Re: Request to Designate the PADCOM potash Mining Project in South West Manitoba

Comments on PADCOM Potash Mine EAP Manitoba Environmental Assessment and Licensing Public Registry 6126.00

by D.M. LeNeveu M.Sc. (biophysics) Nov. 14, 2021

Figure 1. Historical drill holes shown by red dots illustrating the extent of the PADCOM potash resource. Infrastructure and road, rail and river crossings of eventual brine pipelines are shown.

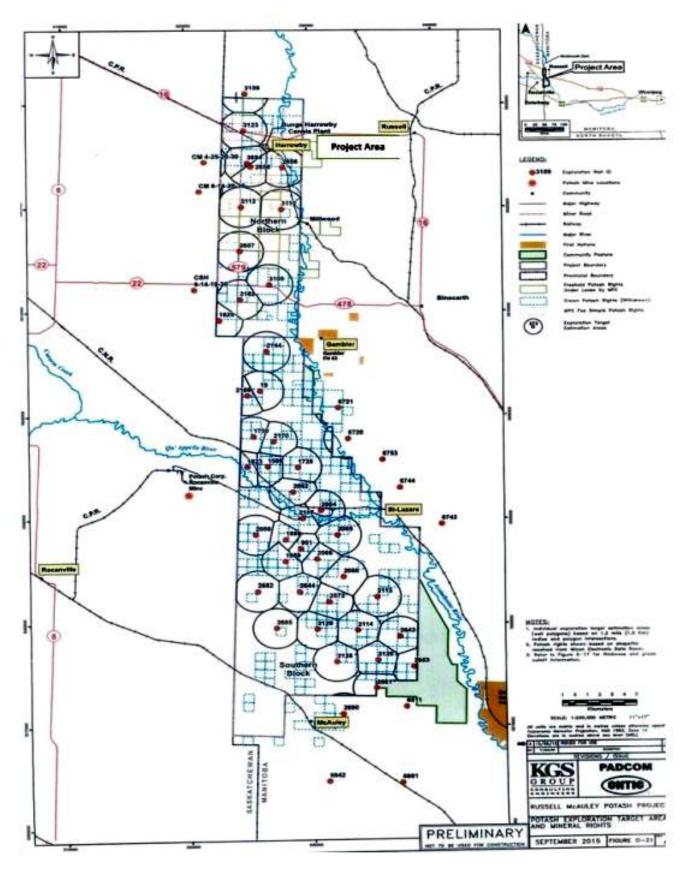
Potash is to be extracted from an extensive deposit about 800 meters below the surface. The extent of the potash deposit is shown in figure 1. A solution mining method would be used where hot 85 C water from the Hatfield Valley Aquifer would be injected into the formation. Horizontal drilling would be employed for a 1600 meter injection leg in the deposit. Dissolved hot potash brine would be pumped from a horizontal recovery well leg and brought to the surface. The method to return the potash brine to the plant site is not described in the PADCOM EAP. Initially only two injection and recovery wells are planned within the processing plant boundary at Harrowby, Manitoba.

The plant is planned to operate all winter. To recover extracted hot potash brine over the entire project area shown would require buried pipelines extending throughout the potash project area of 212 square miles. The pipelines carrying hot brine would cross numerous rivers and streams, provincial and municipal roads, CN and CP rail lines and the 230 kV Birtle interprovincial transmission line. The PADCOM EAP omits consideration of required buried pipelines over the entire 212 square mile project area.

Figure 1. Solubility curves for KCL and NaCL⁹

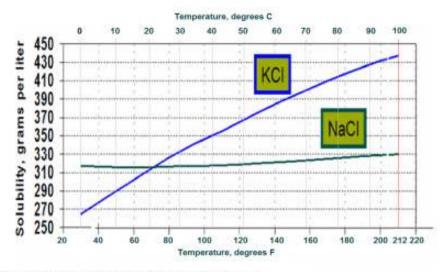
The 0.5 tonnes (500 litres) of water per tonne of KCL produced contradicts the maximum solubility of a predominately KCl and NaCl brine in water at a weight ratio of 1 to 1 (50% KCL in the ore) in water. At 0.5 tonnes of water per tonnes of potash produced there would be more potassium ore to dissolve than water by weight. To further underscore the underestimate of water required in the EAP, below is a graph of the solubility of pure KCl and pure NaCl is water as a function of temperature. According to the graph 420 grams of pure KCL requires 1000 litres of water or 1 kg of water to dissolve to saturation. One tonne of pure KCl would require 2.38 tonnes of water to dissolve to the solubility limit, far greater than the 0.5 tonnes in specified in the EAP.

This evidence establishes that the estimates in the EAP of 0.5 tonnes of water required to produce one tonne of potash are inaccurate and far below what would actually be required.

Figure 2. Some of the critical infrastructure in the PADCOM potash mining area ²⁸

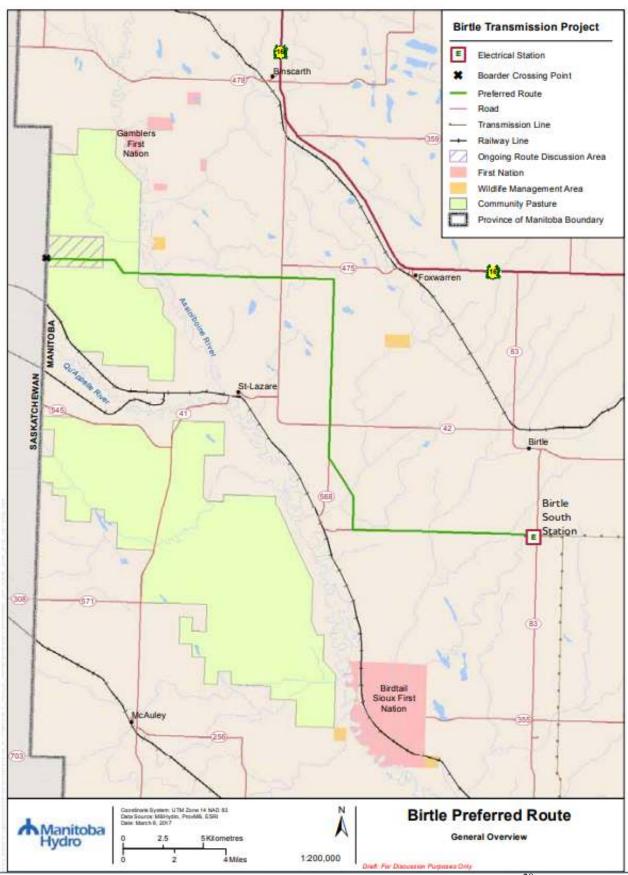
The map in figure 2 from the Birtle Transmission Line planning study illustrates some of the rail, road and transmission line infrastructure that would be affected by the PADCOM project ²⁸ A reproduction of figure 9 in the PADCOM EAP shown in figure 3 shows the extent of the potash resource with respect to infrastructure, and potential eventual brine pipeline crossings of rail, road and river crossings.

Permission must be obtained from MB Hydro for PADCOM pipelines to cross the Birtle Transmission Line.

Figure 3. Historical drill holes shown by red dots illustrating the extent of the PADCOM potash resource. Infrastructure and road, rail and river crossings of eventual brine pipelines are shown.

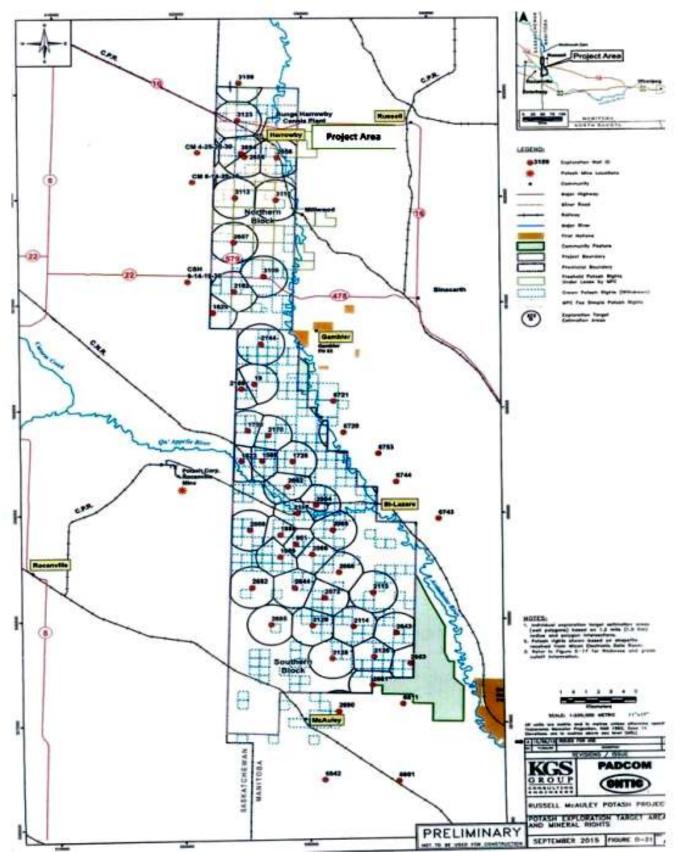
The PADCOM EAP has omitted the critical infrastructure that the brine and hot water pipelines for the injection and recovery wells and the brine disposal wells. As shown in figure 3 of the EAP the project potash mining area covers 212 square mines where much critical infrastructure exists but has not been identified. The EAP deliberately omits the requirement for buried pipelines to convey hot water and brine over the entire mining area and does not show the eventual route of the required pipelines.

Many rivers and streams must be eventually crossed by the brine pipelines including the Qu'Appelle River. A brine spill in any of these rivers and streams would adversely affect fish and Fish habitat. All fish bearing water courses that must be eventually crossed by PADCOM brine pipelines must be identified and the Fisheries and Oceans Canada (DFO) and the IAAC notified of these crossings. Mitigation measures to minimize the risk of brine spills and detriment to fish habitat in consultation with the DFO and the Fish and Fish Habitat Protection Program under the Fisheries Act and Species at Risk Act must be implemented.²⁸
